Supplement to 18/015 York Station Frontage RSA1

Safety Review

Element under review – Cycle facilities on Queen St outside No. 11-20

Option 1 – On Road Cycleway

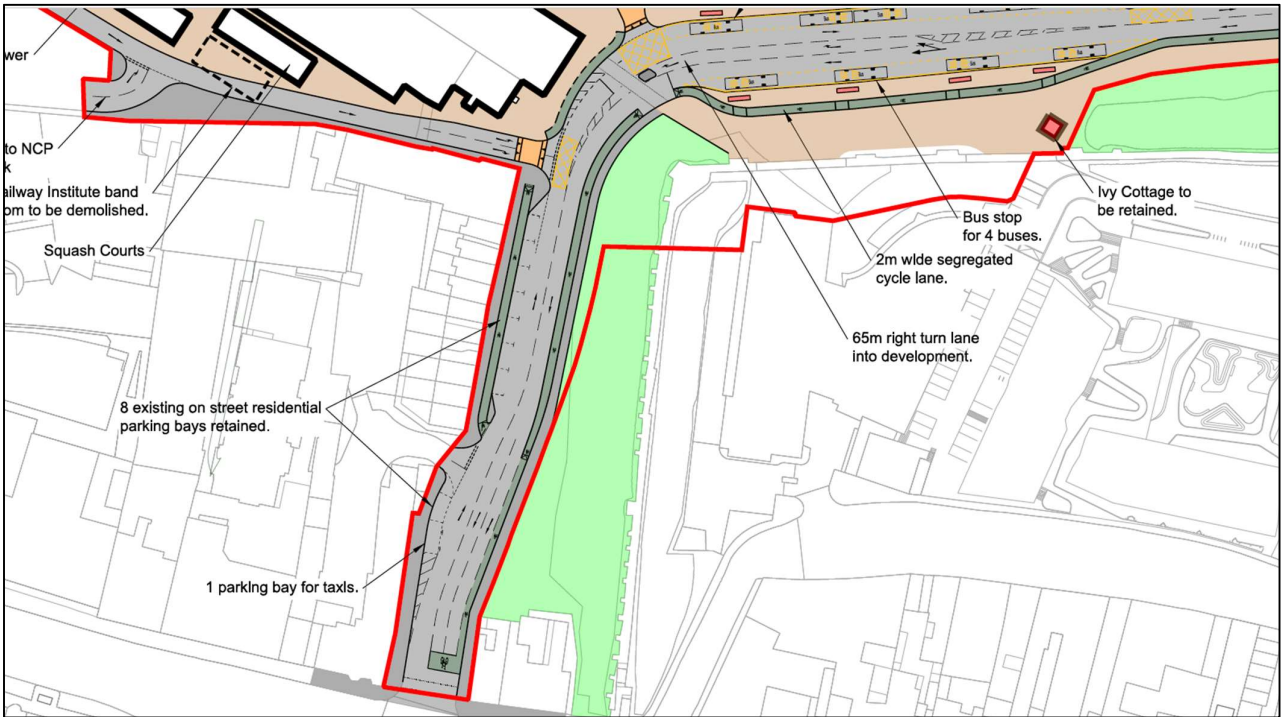
1. The cycle route is continuous from the Blossom St signalised junction. Cyclists are not expected to give way at any point and drivers are aware of where they should expect to see cyclists.
2. Separates cyclists from pedestrians, reducing the chance of a collision.

1. The southern end of the layby creates a pinchpoint. This could lead to cyclists being squeezed between larger vehicles and the kerb.
2. Cyclists could be squeezed between parked vehicles and traffic in the running lane. Buffer does alleviate this issue somewhat.
3. Cycle conflict with car doors. This is no worse than any other location where cyclists pass parked cars and the presence of the buffer does give extra space to cyclists.

Option 2 – Off Road Cycleway

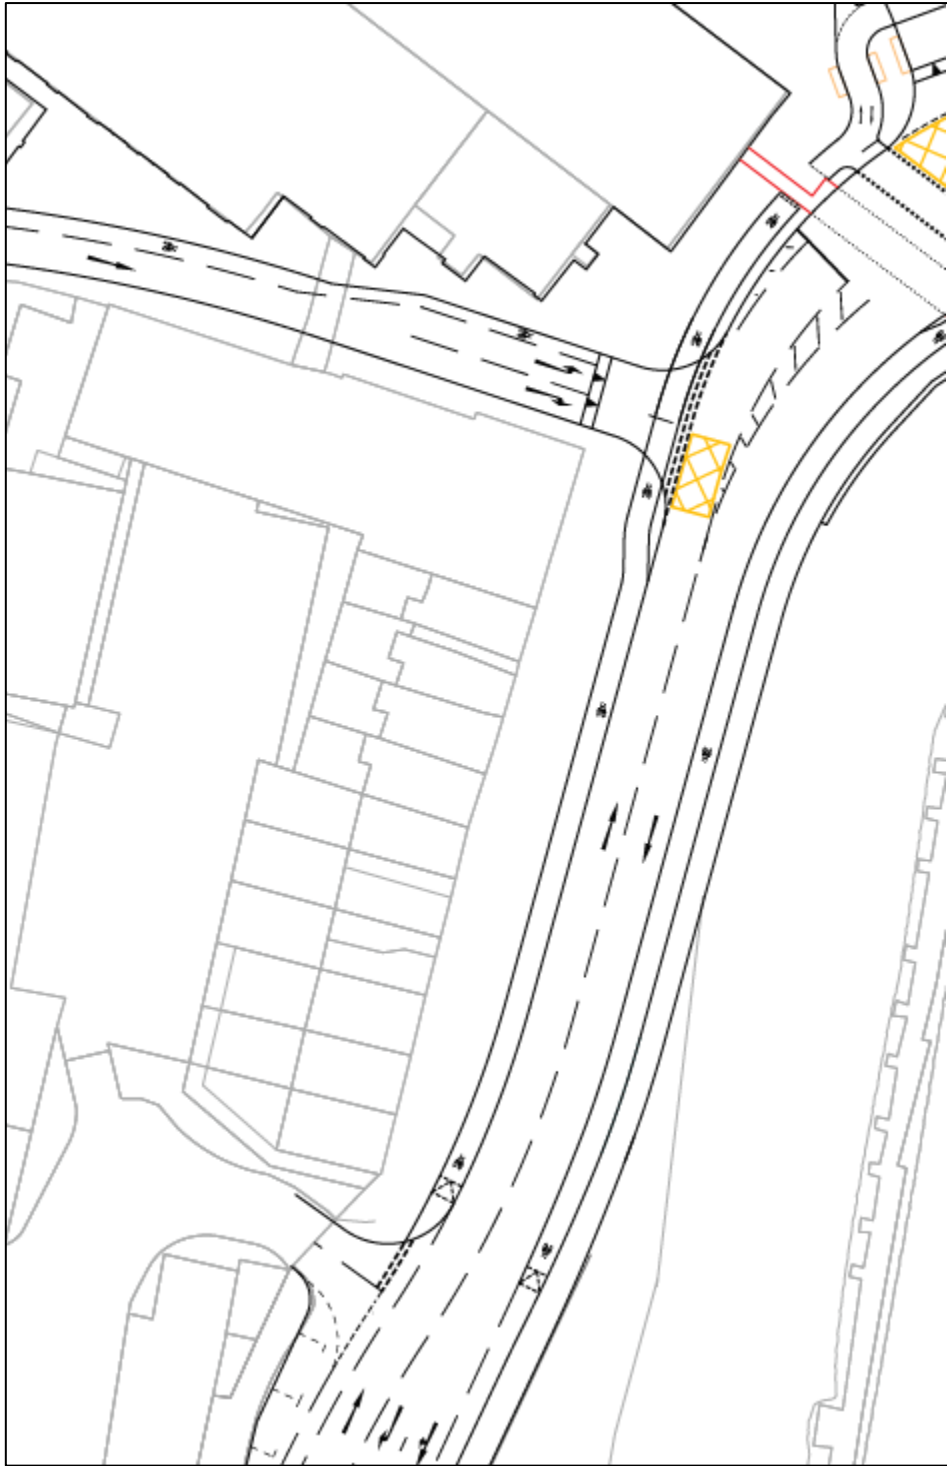
1. Cyclists are segregated from traffic, reducing the chance of a collision.

1. Increased risk of cycle / car door conflict. The cycle path on the footway adjacent to parked cars arrangement is unconventional. Car users (most likely passengers) are less likely to check for a cyclist on the footway than on the carriageway before opening their door.

2. Cycle path could be blocked by doors for longer. Car users accessing their vehicle to remove baby seats or assist children in car seats will block the cycle lane for prolonged periods. This is less likely in the carriageway as car users will not wish to put themselves at risk in live traffic.

3. Cyclists will need to mix with pedestrians if trying to cycle at an advisable distance from the parked vehicles. This footway will become the main pedestrian route between Blossom Street and the Station once Queen St Bridge is removed increasing the footfall significantly. At busy times it is likely that pedestrians will also use the space allocated to cyclists. This increases the chance of a pedestrian / cyclist collision.

4. Off road cycle paths are often used in both directions even if they are designed for one way working. This will further increase the chance of conflict with pedestrians and car doors.

5. Off road cycle paths are often used in both directions even if they are designed for one way working. This could lead to some users trying to cross Queen Street at the entrance to the Premier Inn.

6. Off-road path abruptly ends on the footway in front of the Railway Institute. Nothing on the design to suggest what cyclists are expected to do at this point. If area is to be shared use then same concerns as issue 3 are valid.
7. The lack of a continuous priority cycle route from Blossom Street means that cyclists may choose to stay on road increasing the chance of collisions on the route.
8. There is no buffer provided past the taxi stands for on road cyclists.
